**Proof of Evidence relating to the Statement of
Matters (211027) item 4; impact on Hobson's Park
and Nine Wells Local Nature Reserve.**

**IN RESPECT OF THE TRANSPORT AND WORKS ACT 1992: APPLICATION FOR
THE PROPOSED NETWORK RAIL (CAMBRIDGE SOUTH INFRASTRUCTURE
ENHANCEMENT) ORDER**

Planning Ref: 20/05054/CTY,
21/02957/TWA

Alistair Wilson (Streets and Open Space – Development Manager)

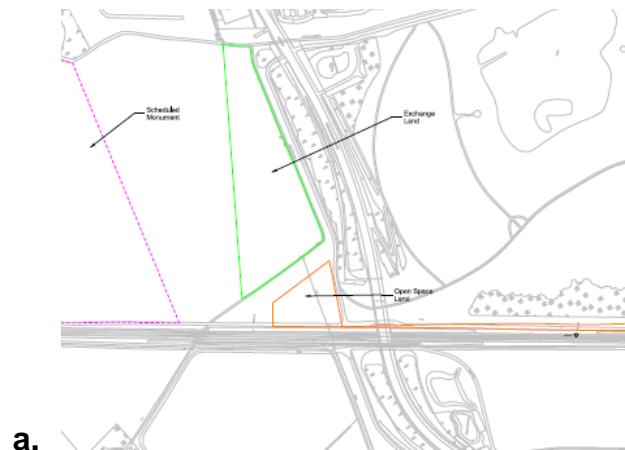
- i. The exchange land is bordered by Addenbrookes Access Road (AAA) to which the Clay Farm is predominately built to the North. The AAA is a very busy road and there are currently no controlled crossing points to allow access to the exchange land.
- ii. The exchange land is only accessible (without crossing AAA) from the Hobson's Park by access under the Addenbrookes Road bridge. This land also includes railway infrastructure in proximity. See the plan extract below.
